TECHNICAL BULLETIN No. 81 DATE: 10/09/09

SUBJECT: EMC7586V Under Cooking in Convection Mode

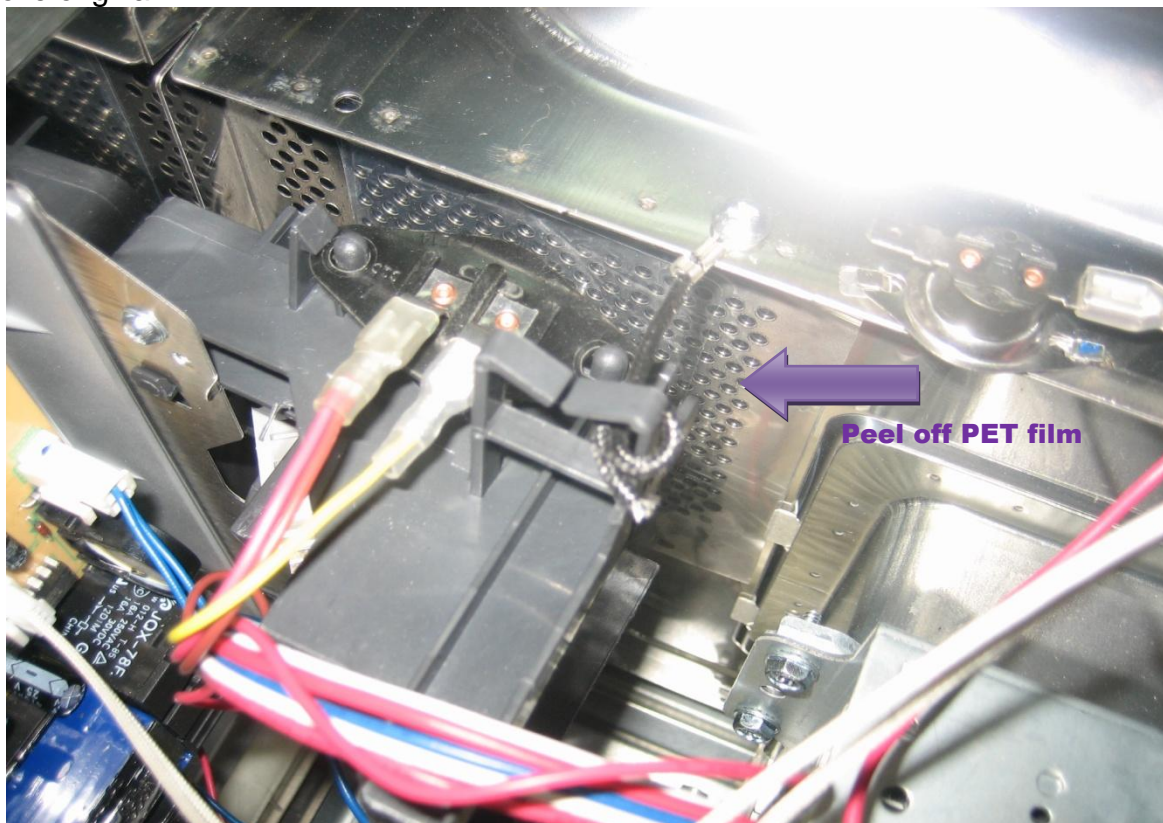
Not reaching programmed convection temperature.

Temperature sensor PN: MM51401000008 is not the correct type and too much ventilation of oven cavity.

Replace Temperature sensor and PET film PN: EMC7586VMOD.

- Remove cabinet cover.
- Replace Temperature sensor.
- Remove original PET film

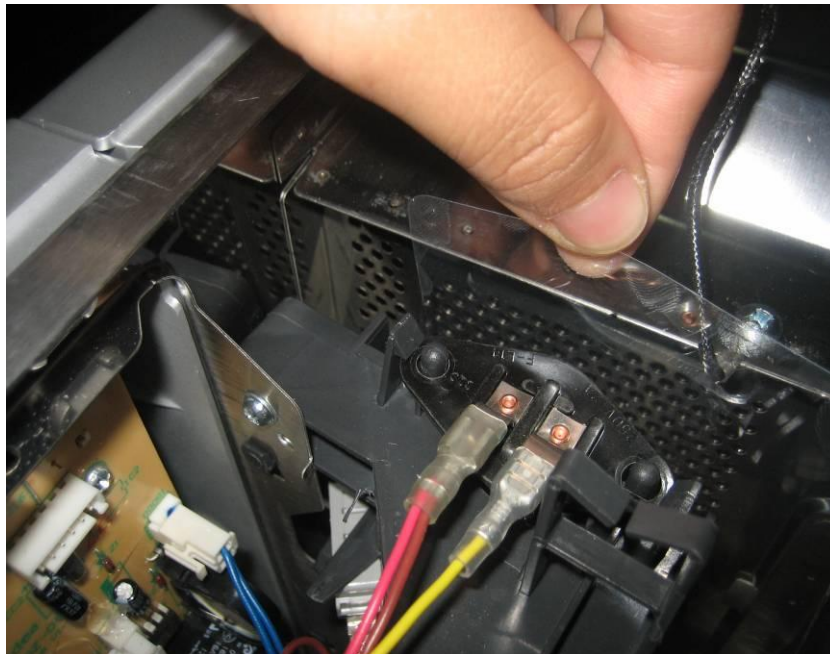
- Insert new PET film

- Make sure that only the red area is covered and leave blue free.
